USB4 2.0 ENGINEERING CHANGE NOTICE FORM

Title: Gen 4 Link Recovery Timing Constraints Applied to: USB4 Specification Version 2.0

(e). ECN INFORMATIVE

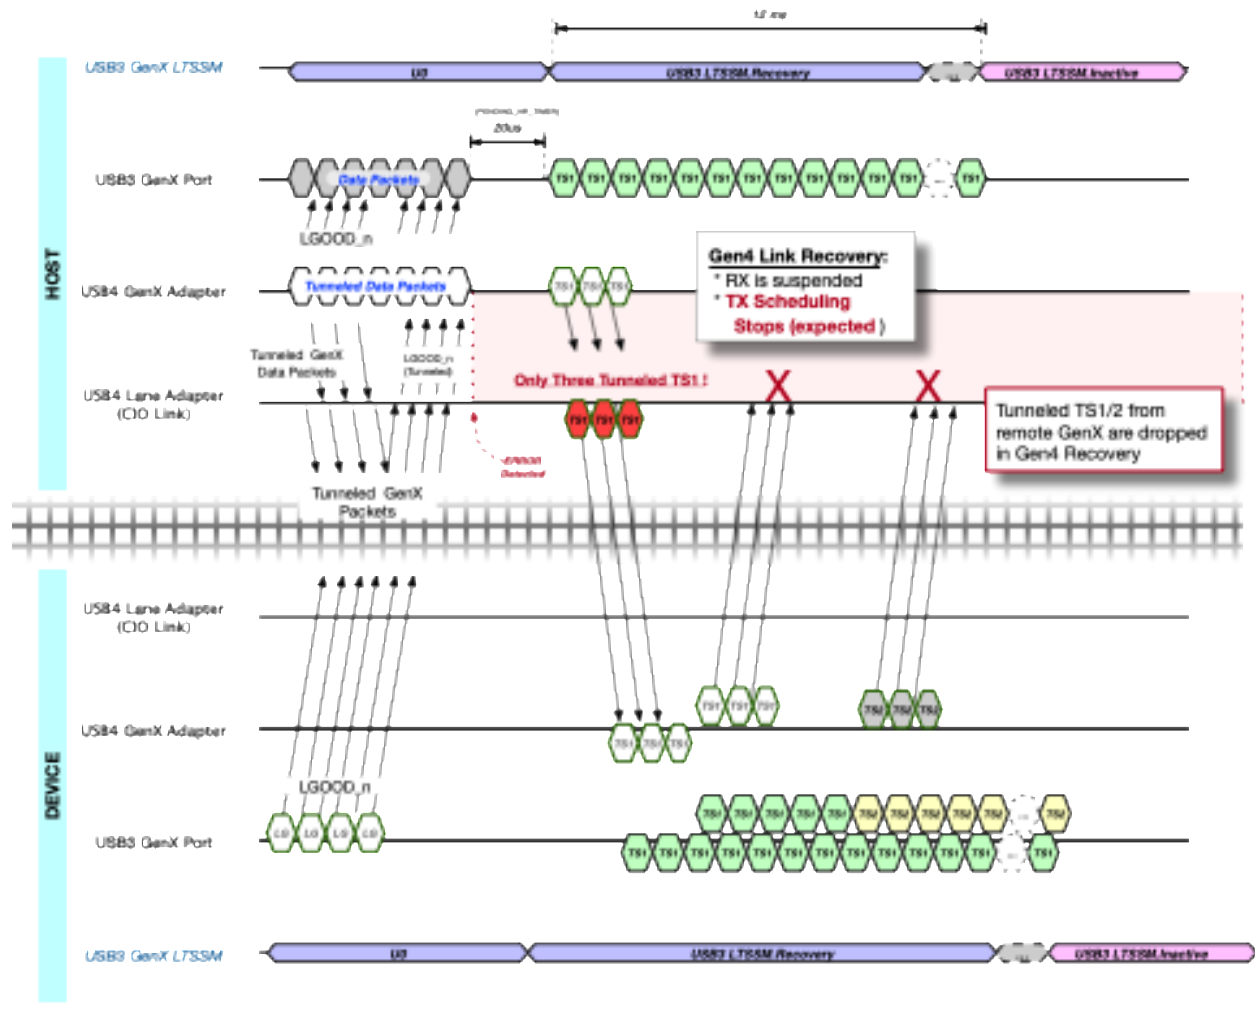
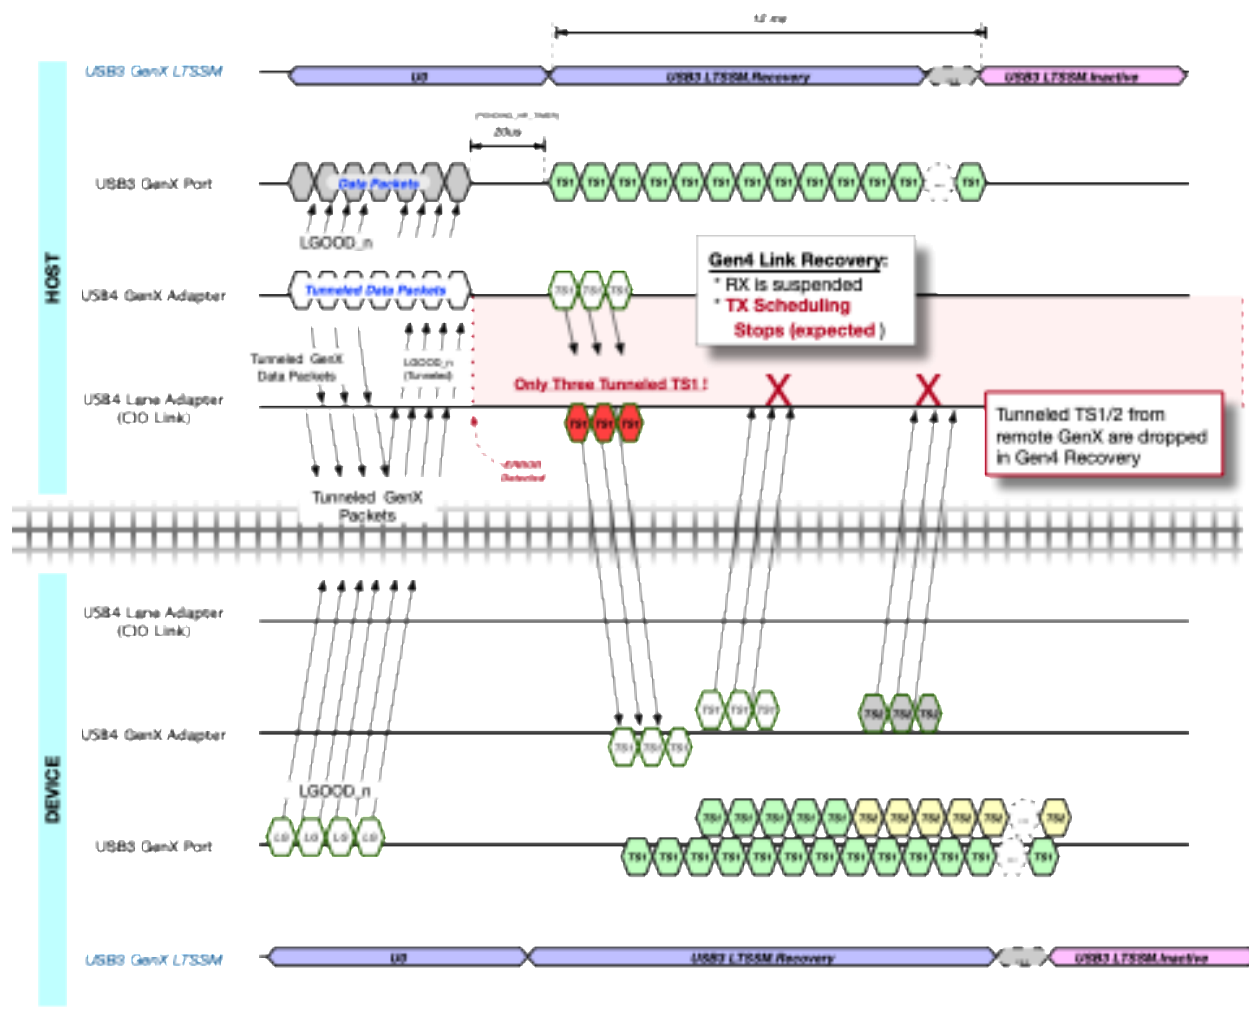
The below diagram provides an example in the case of USB3 Gen X tunneling.
